Economic Commission for Europe**Inland Transport Committee****World Forum for Harmonization of Vehicle Regulations****Working Party on Passive Safety****Seventy-sixth session**

UN Regulation No. 134 (Hydrogen and Fuel Cell Vehicles)**Proposal for the 03 Series of Amendments to UN Regulation No. 134 (Hydrogen and Fuel Cell Vehicles)****Submitted by the Task Force amending UN Regulation No. 134 ***

I. Proposal

Figure 2
Verification Test for Expected On-Road Performance (Pneumatic/hydraulic)

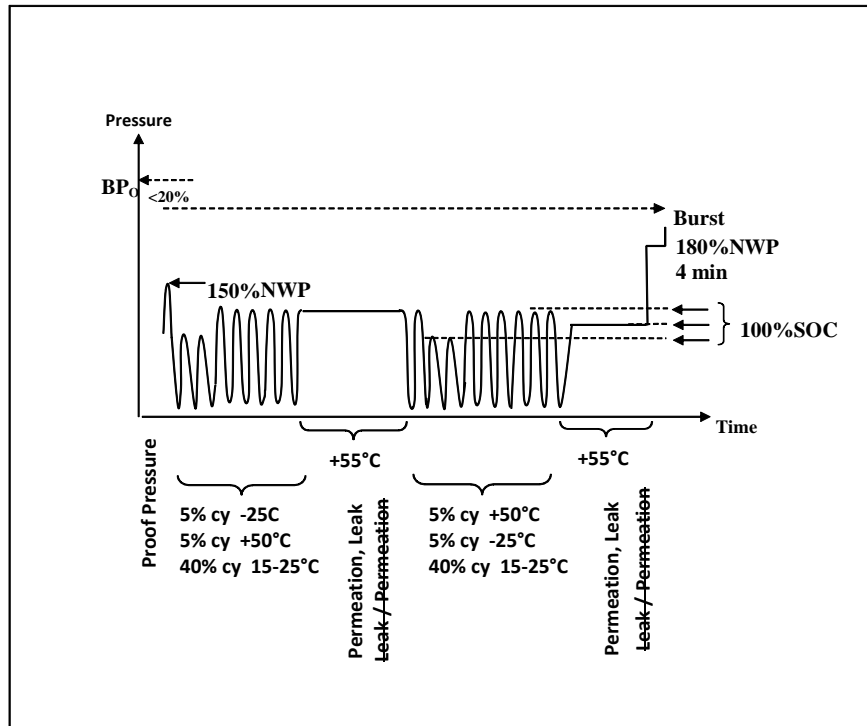
A CHSS shall undergo the following sequence of tests, which are illustrated in Figure 2. Specifics of applicable test procedures for the CHSS are provided in Annex 3. [**At the discretion of the Technical Service and the Type-Approval Authority, for supply lines for additional TPRDs the worst-case approach may be applied, e.g. longest lines, largest diameter, smallest bend radius and highest number of fittings.**]"

Figure 2., amend to read:

This proposal clarifies the order of the permeation and leak test in Figure 2 in alignment with the text and, in addition, streamlines the wording for headlines and text regarding these tests. There is no change to the technical requirements.
